Ground Floor Strategy

Consented Scheme

Revised Scheme

Revised Scheme - Fifth to Sixth Floor Plan

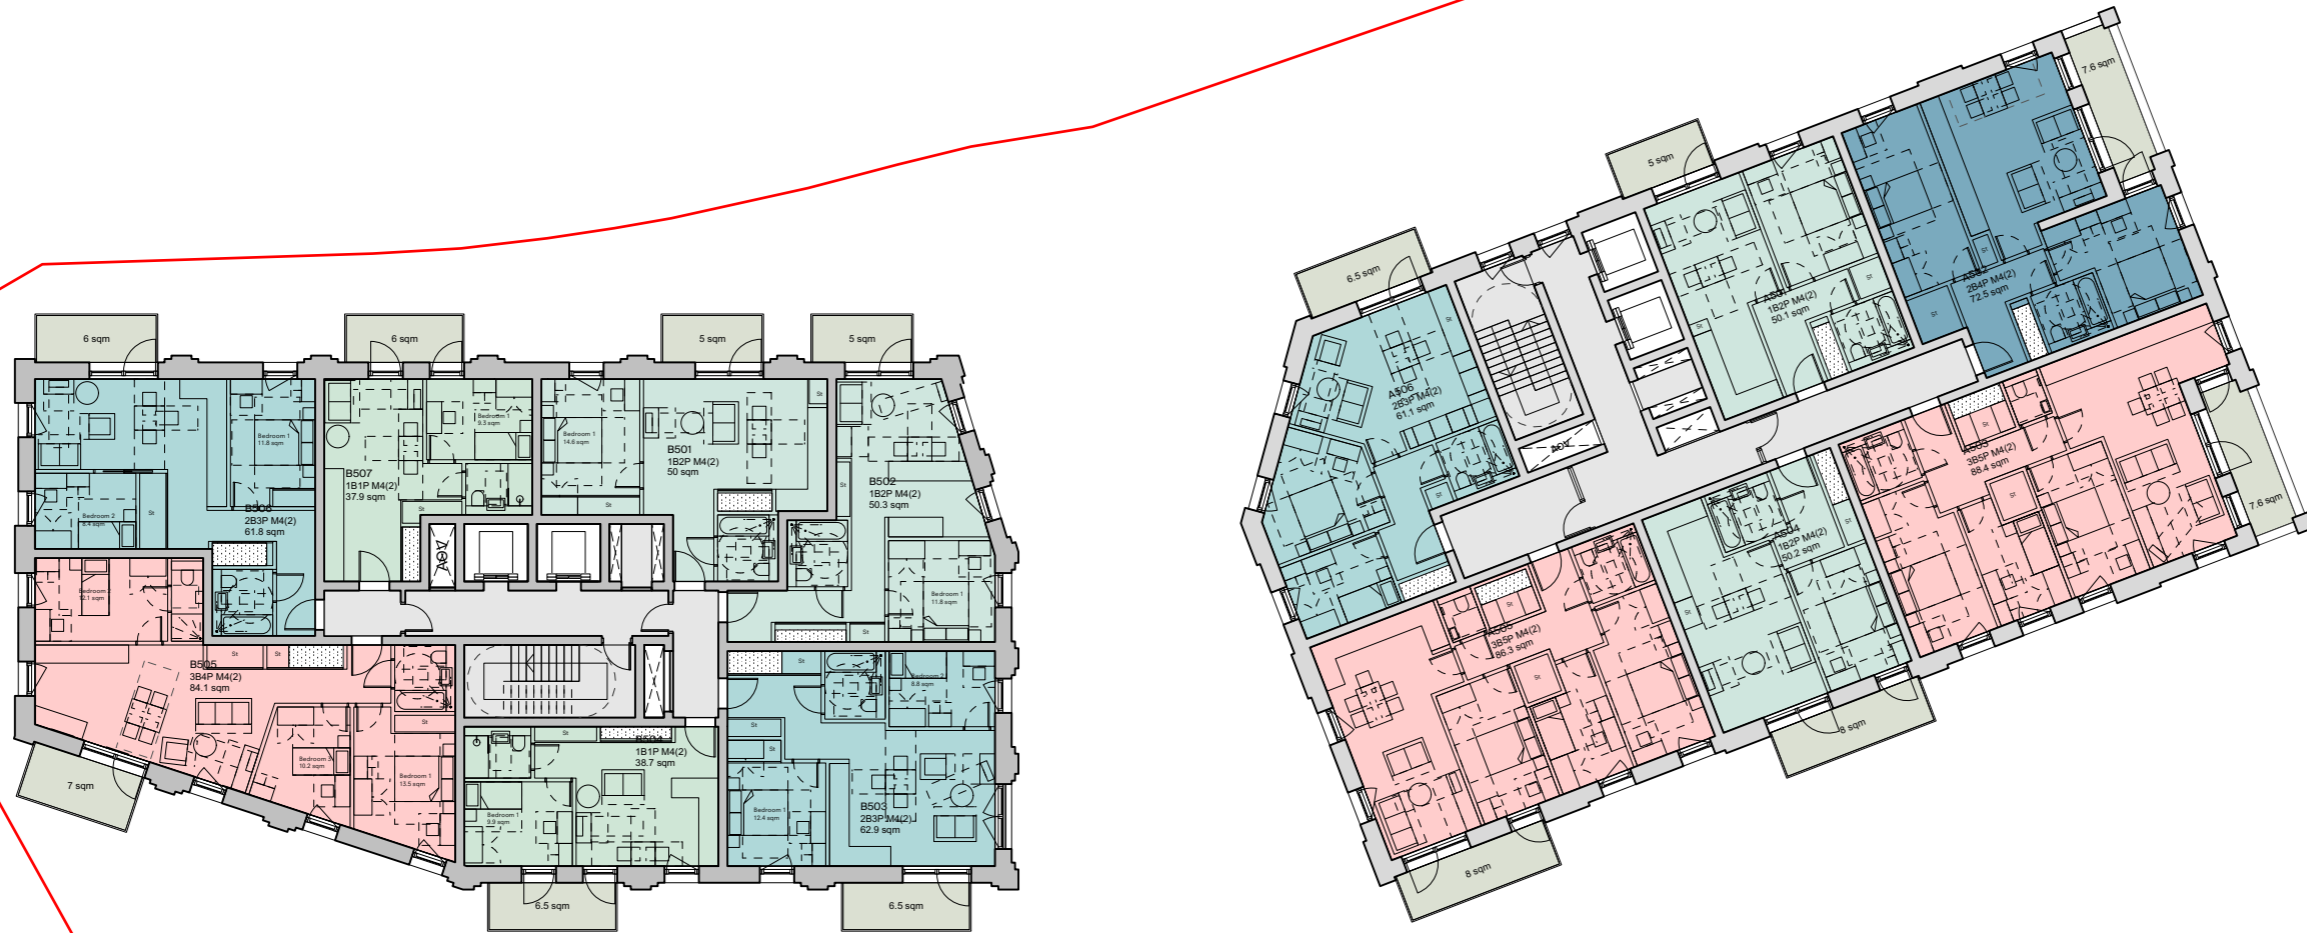
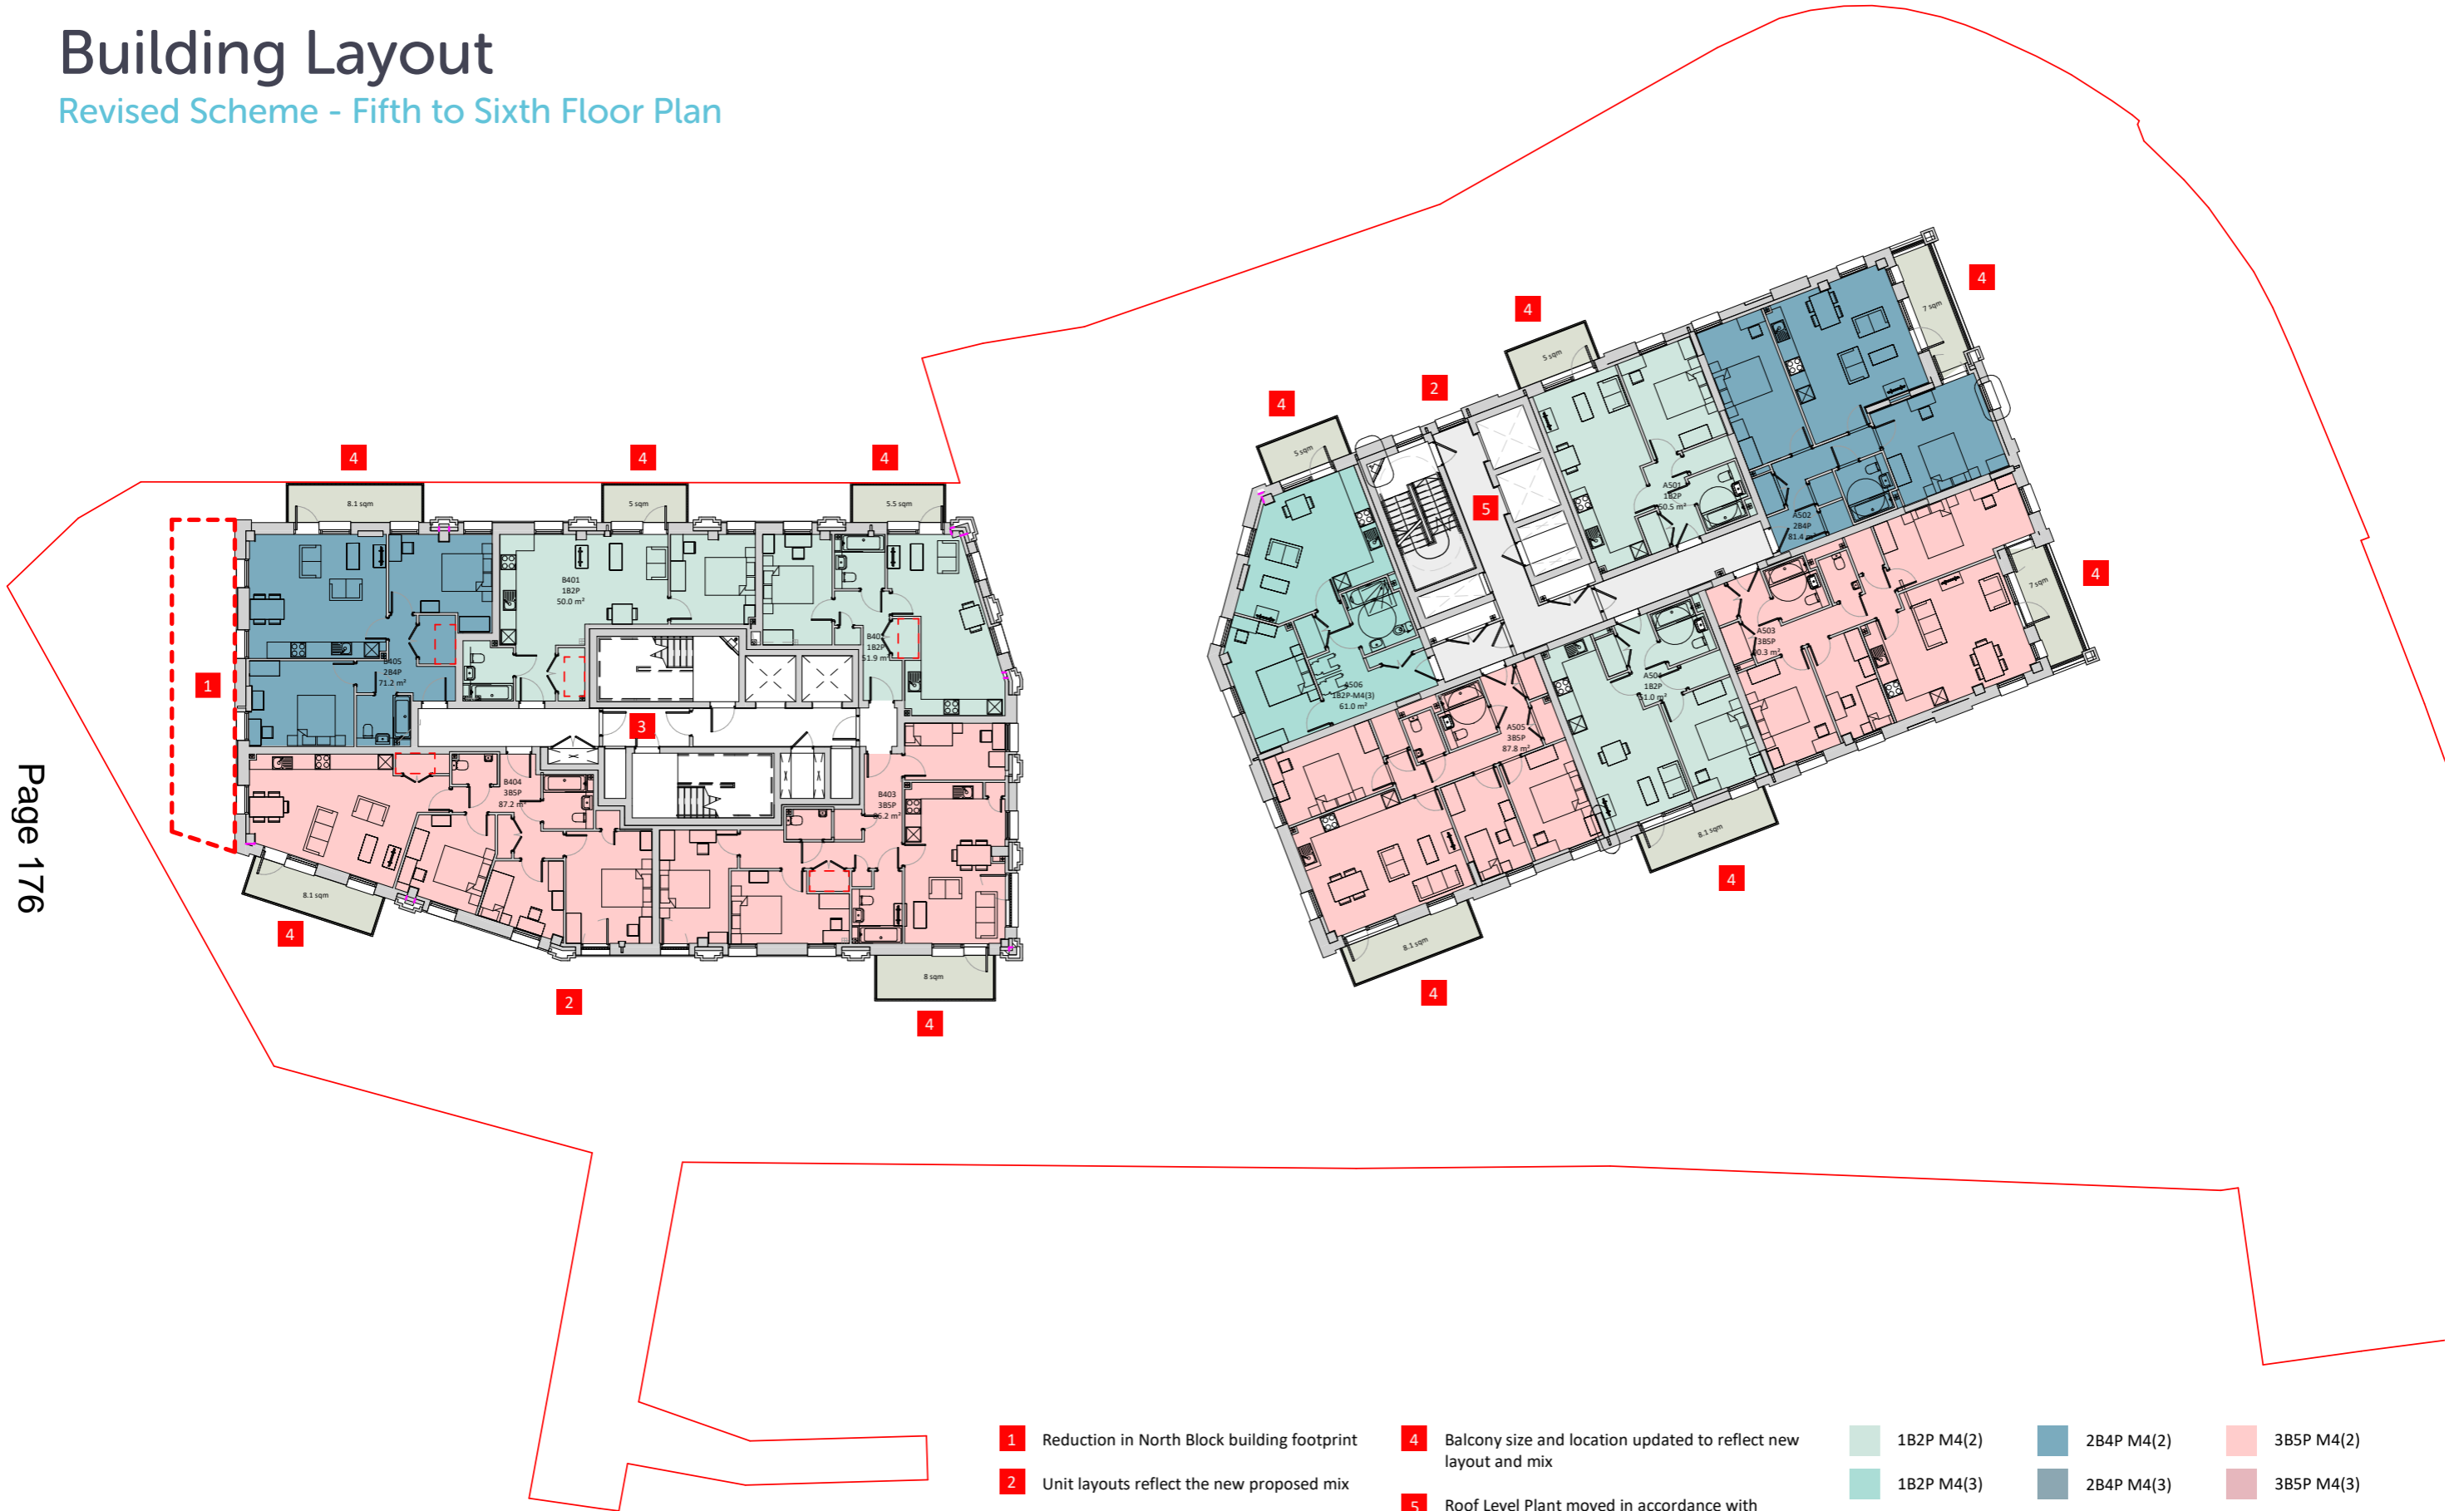
- 1** Reduction in North Block building footprint
- 2** Unit layouts reflect the new proposed mix
- 3** Revised core to accommodate secondary escape stair an additional vents and risers

- 4** Balcony size and location updated to reflect new layout and mix
- 5** Roof Level Plant moved in accordance with below core shift
